| TSB140137 |

ISX 12/15 CM2250/CM2350 Variable Geometry Turbocharger (VGT) Turbocharger Bearing Housing Coolant Leak Test - Service Tool Leaks

Figure 1

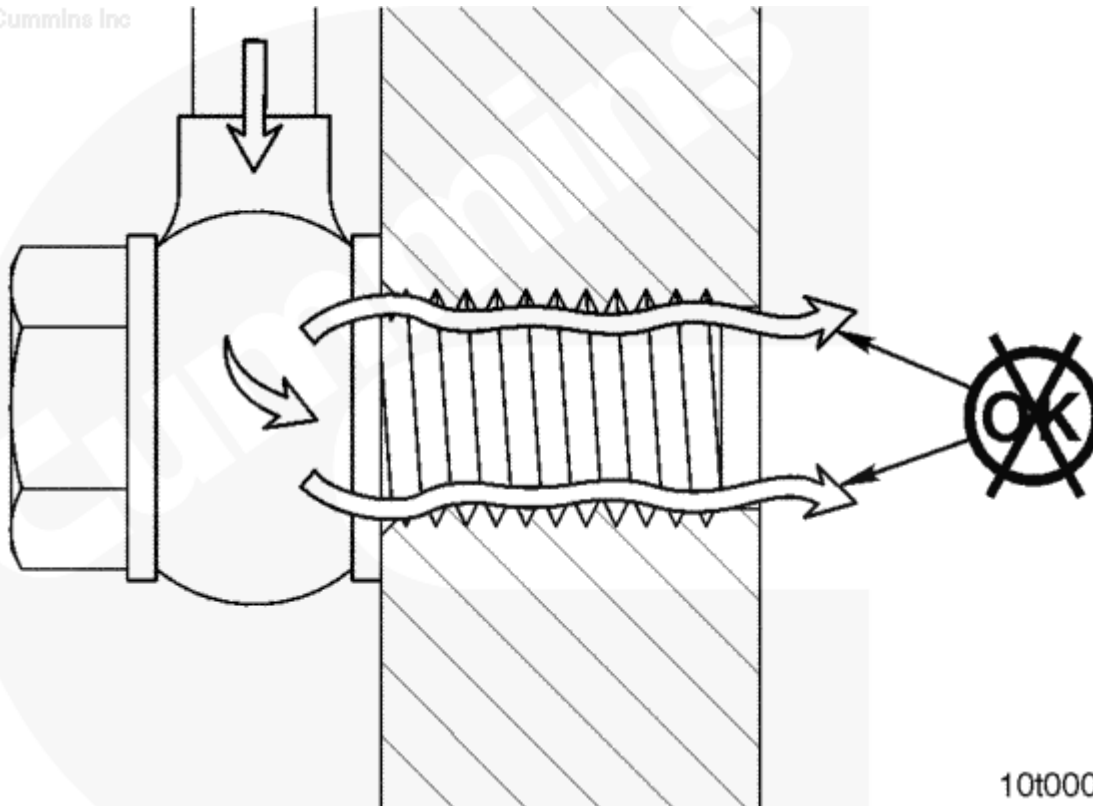
Turbochargers are being returned due to failing the bearing housing leak test when using Service Tool Kit, Part Number 2892101, as described in Procedure 010-033 (Turbocharger) in the service manual. It was found that the actual leak was caused by the service tool. The block off fittings do **not** provide enough shoulder for the inner seal of the banjo washer to seal properly, allowing air to leak down past the bolt and mating component threads. See Figure 1.

Pack the threads of the block off fittings with an all-purpose or bearing grease to seal off air leaks caused by the service tool. After the test, wipe off the grease from mating components. Use new sealing washers, since the grease may **not** be compatible with seals in the cooling system.

Figure 2

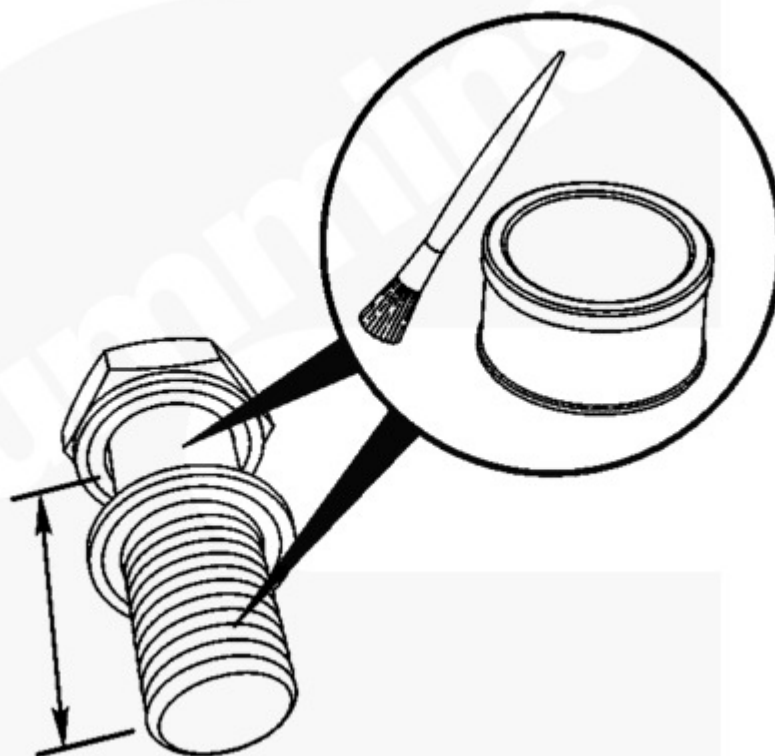
Complete the leak test in Procedure 010-033 (Turbocharger), following the additional instructions provided below for the service tool.
